Recall Inspection and Repair Instructions

NHTSA Recall #: 22V-273

Tiffin Motorhomes Recall #: TIF-122

Models Involved: 2021 Allegro Open Roads 34 PA & 36 UA floorplans, 2022 Allegro Open Roads, 32 FA, 32 SA, 34 PA, 36 LA, 36 UA floorplans and 2022 Allegro Bays, 38 AB & 38 BB floorplans

Figure 5:
Cotter pin

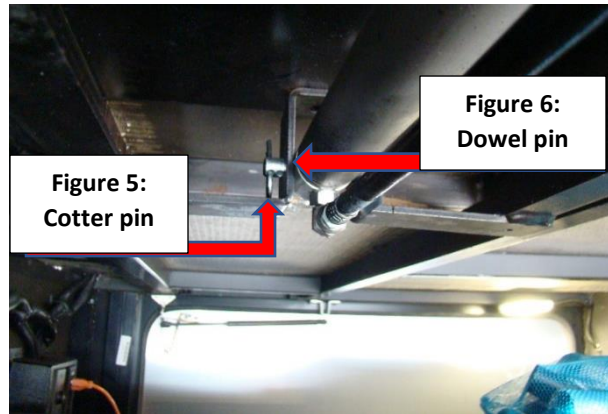
8. Pull cotter pin (figure 5) from dowel pin (figure 6) at base of slide cylinder.
9. Remove dowel pin (figure 6) from base of slide cylinder.

**Figure 8:
Hex stop bell**

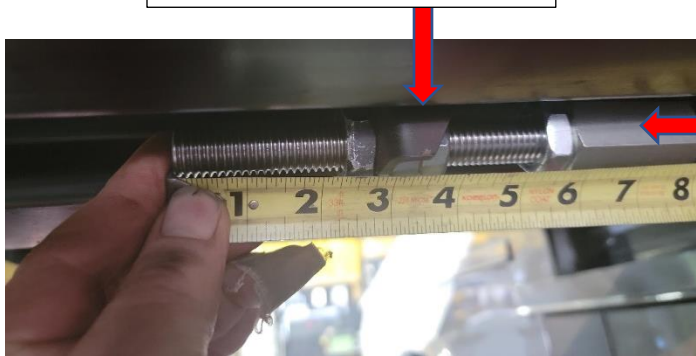
- a. 3" from threaded end of cylinder to first of two nuts side of rod end cylinder mount. (Figure 7)
- b. 8" from threaded end of cylinder to far side of hex stop bell (figure 8). Secure in place with 3/4 nut with a 1 1/8" wrench. (See image below)
